## 7 Railway Street Chatswood

| Meeting   | <b>Railcorp Meeting</b>                                                                                                                                                                                                                        |
| Date      | <b>Friday 18 June 2010</b>                                                                                                                                                                                                                     |

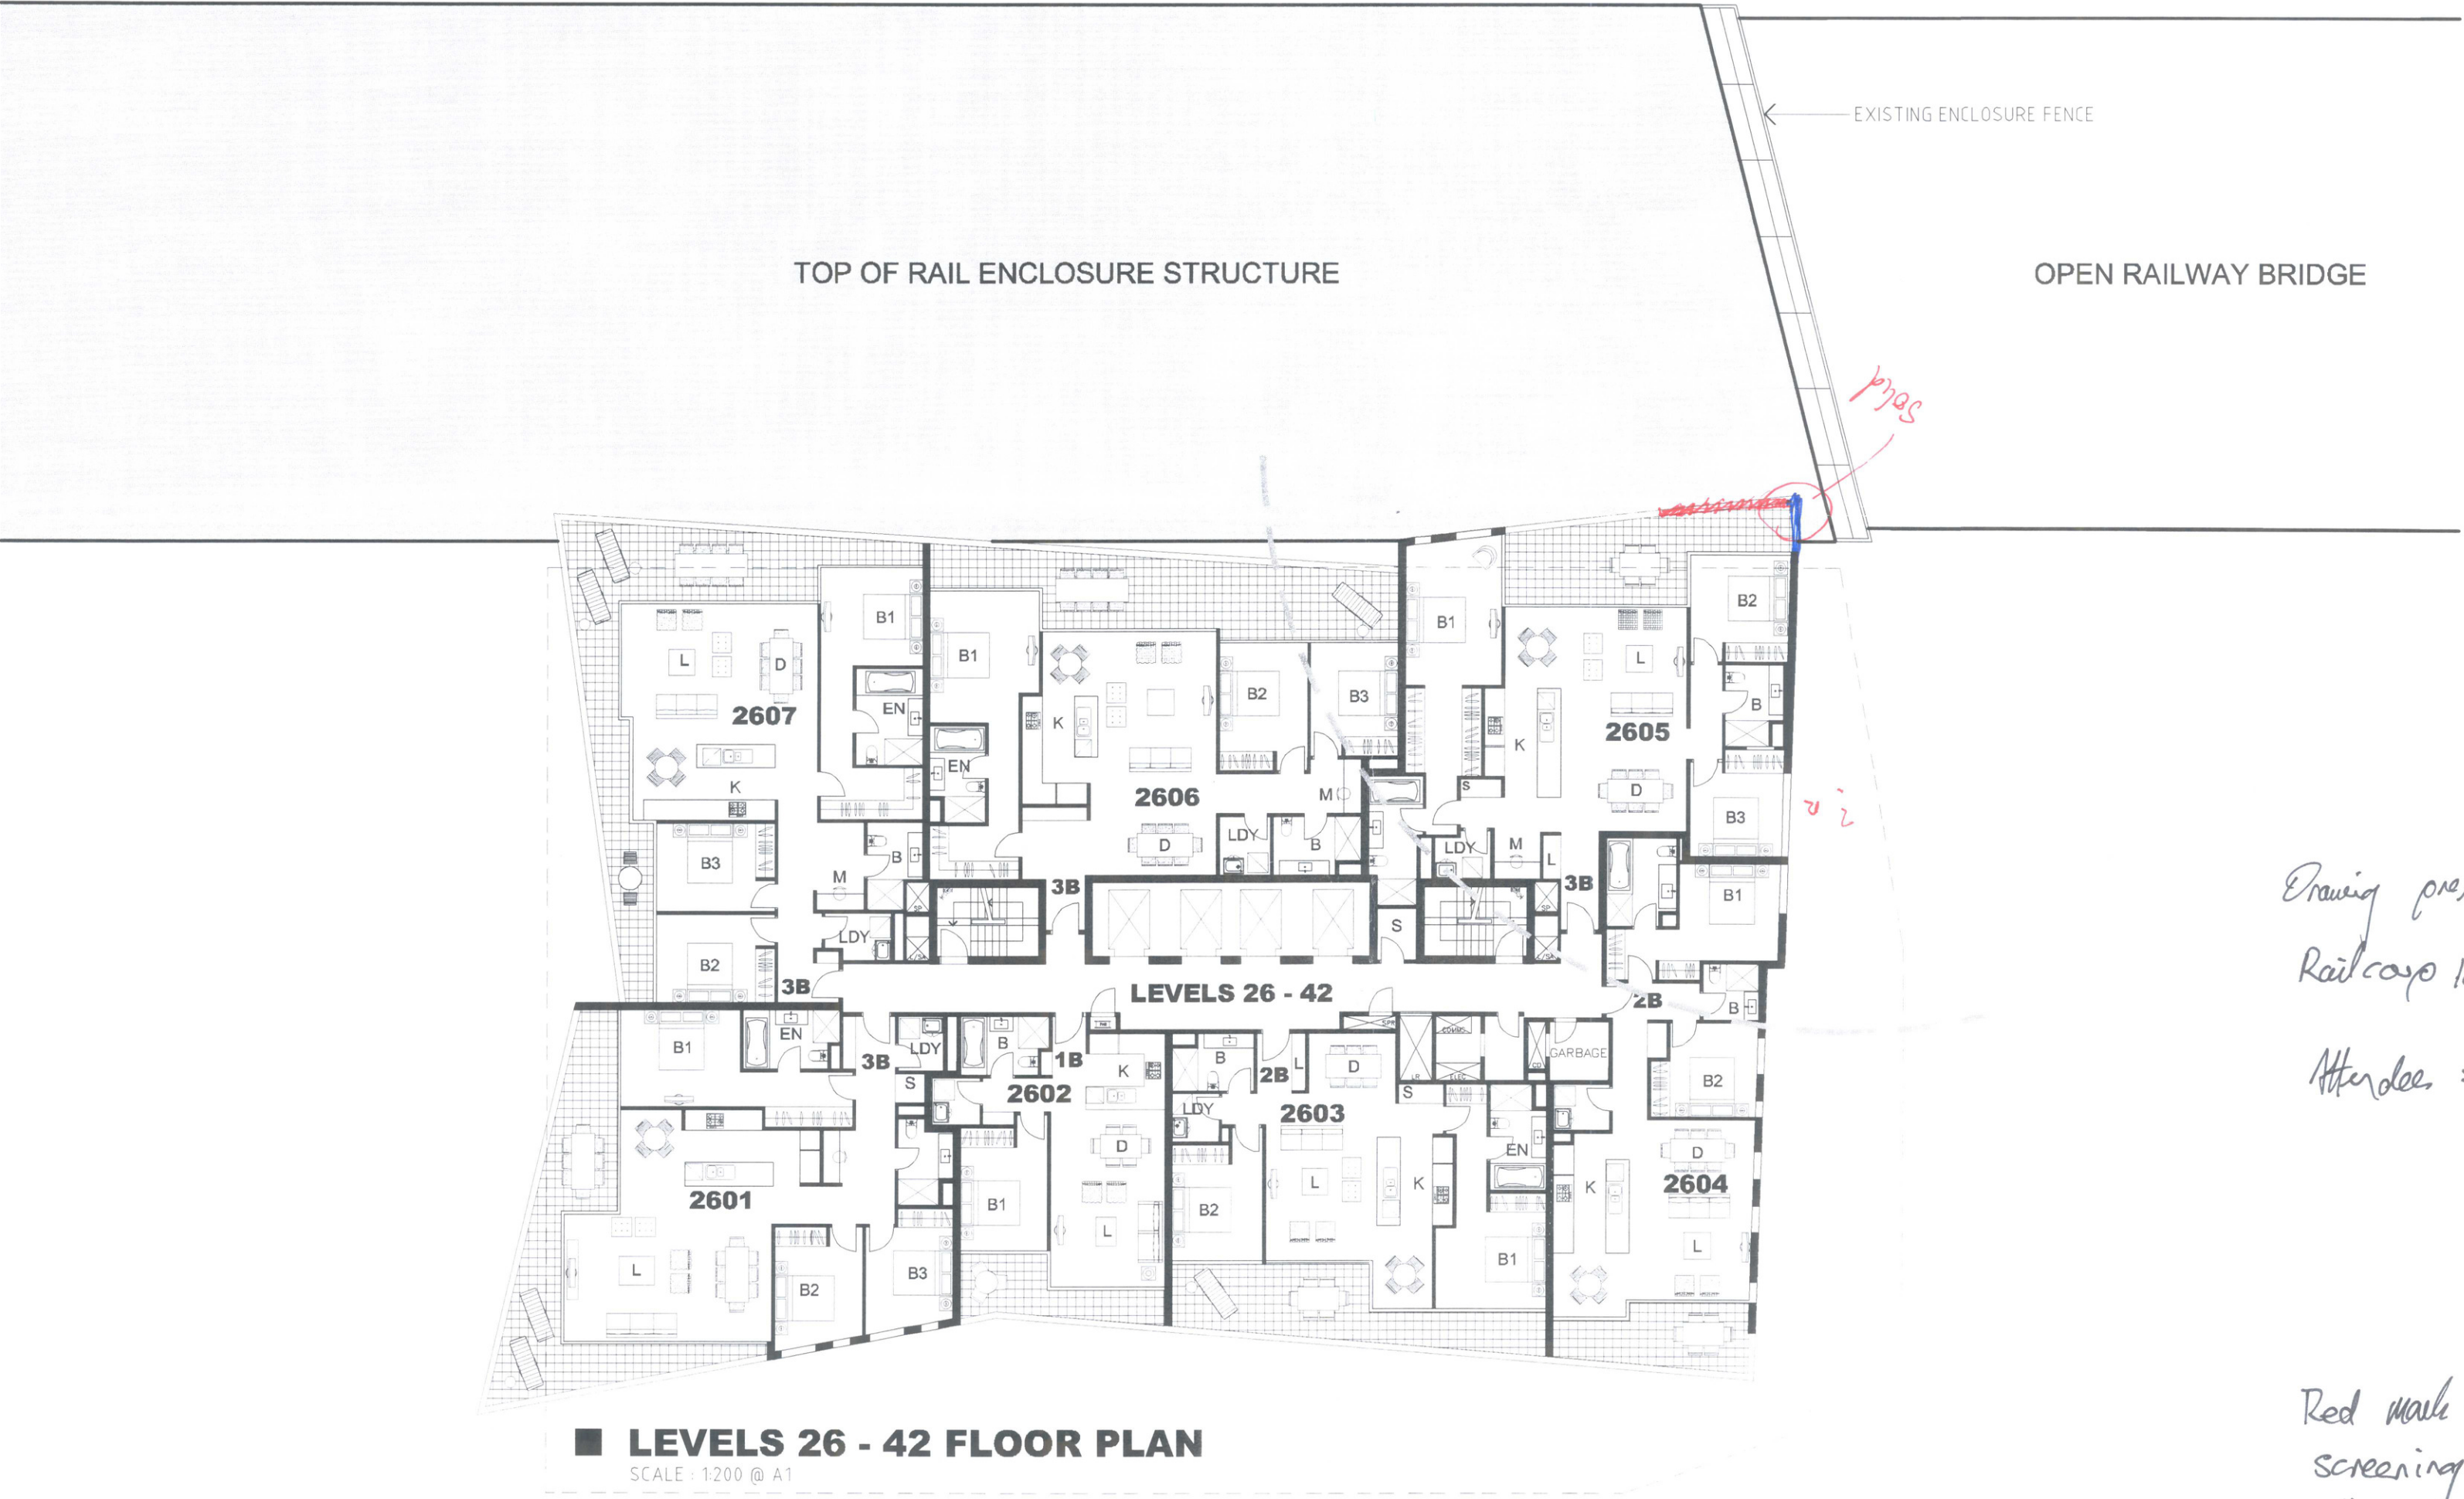
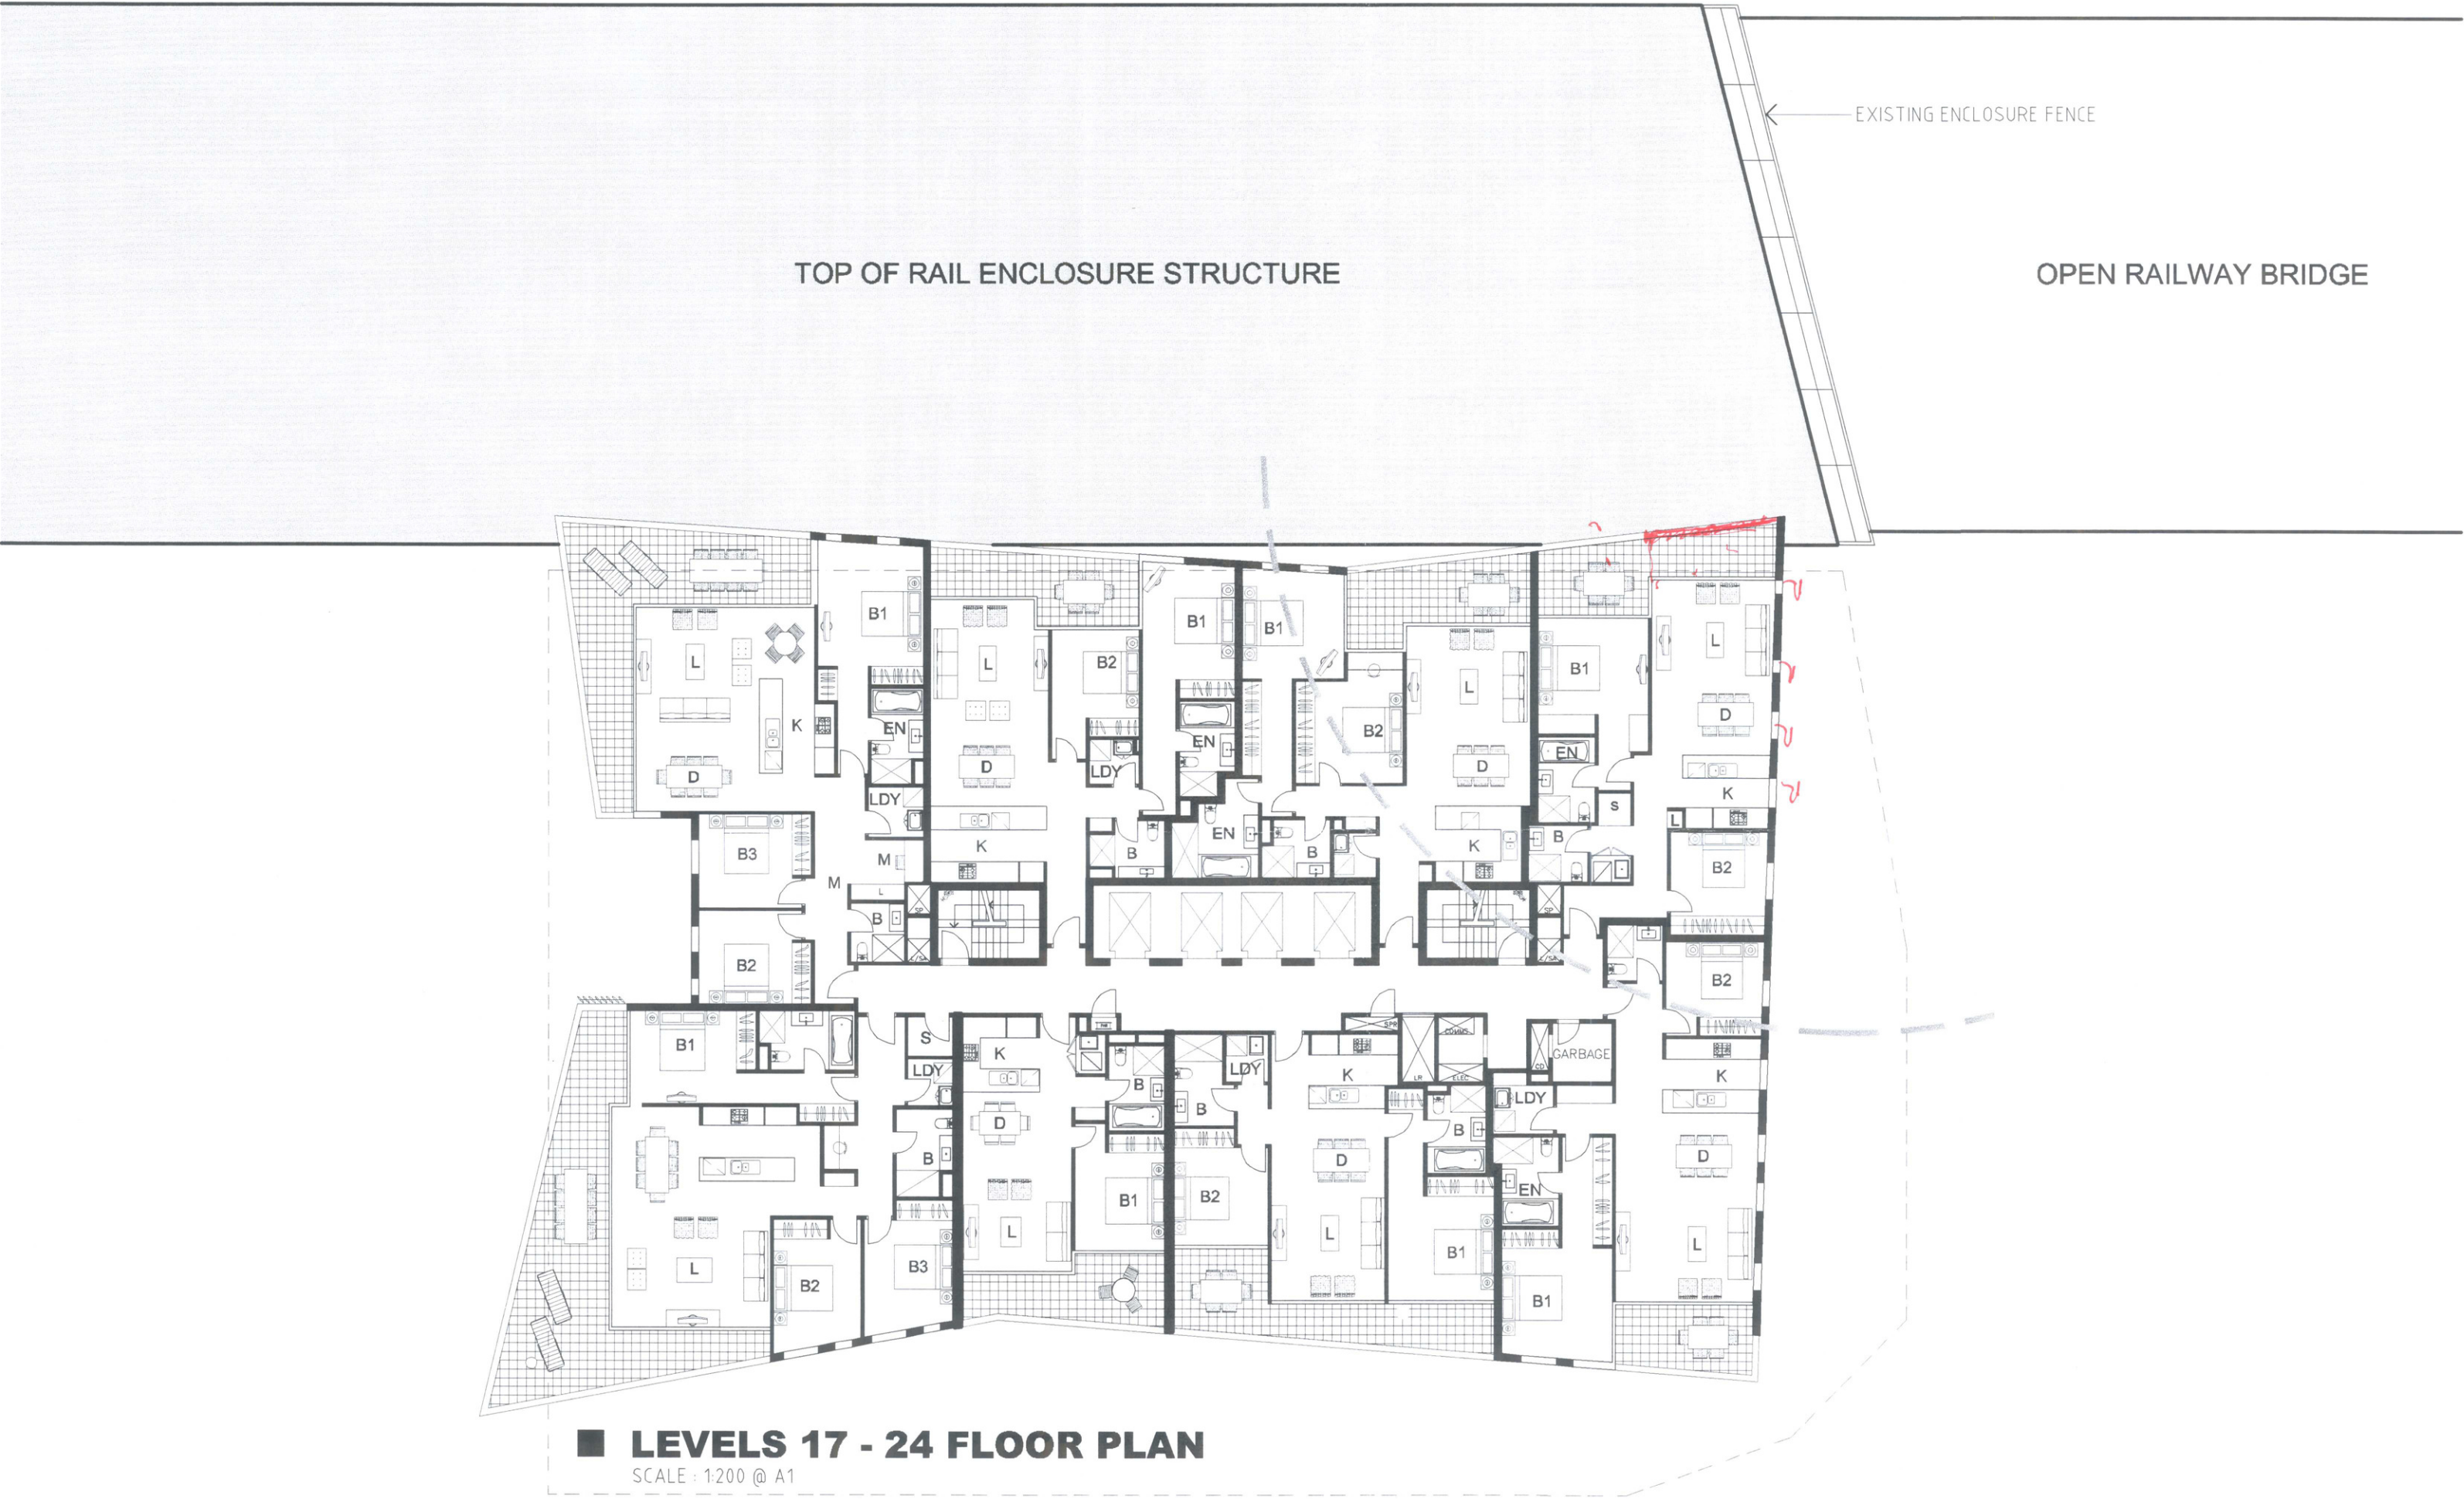
| Item | Description                                                                                                                                                                                                                                                                                                                                                                                                                                                                                                                                                                                                                                                                                                                                                                                                                                                                                                                                                                                                                                                                                   | Action                             |
|------|-----------------------------------------------------------------------------------------------------------------------------------------------------------------------------------------------------------------------------------------------------------------------------------------------------------------------------------------------------------------------------------------------------------------------------------------------------------------------------------------------------------------------------------------------------------------------------------------------------------------------------------------------------------------------------------------------------------------------------------------------------------------------------------------------------------------------------------------------------------------------------------------------------------------------------------------------------------------------------------------------------------------------------------------------------------------------------------------------|------------------------------------|
|      | <p>high rise) and by orientating the east facing façade on a splay away from the uncovered rail corridor.</p> <p>Mirvac / Railcorp reviewed the apartments and marked up the attached plan showing the extent of louvres and/or screening required to balconies “facing” the uncovered rail corridor and the windows requiring restrictors. In summary:</p> <ul style="list-style-type: none"> <li>- Apartment 507 (Low Rise): Enclosure of balcony and restrictors on windows to southern façade</li> <li>- Apartment 506 (Low Rise): Fixed louvres and/or screening approx. 500mm in length to south-eastern portion of balcony (as marked)</li> <li>- Apartment 1705 (Mid Rise): Fixed louvres and/or screening approx 4000mm in length to eastern portion of balcony in front of the living room (as marked) and restrictors to south facing windows</li> <li>- Apartment 2605 (High Rise): Solid blade wall to south-east balustrade adjacent to Bed 2 and fixed louvres and/or screening approx 4000mm in length to eastern portion of balcony in front of Bed 2 (as marked)</li> </ul> | <p>Agreed by Mirvac / Railcorp</p> |
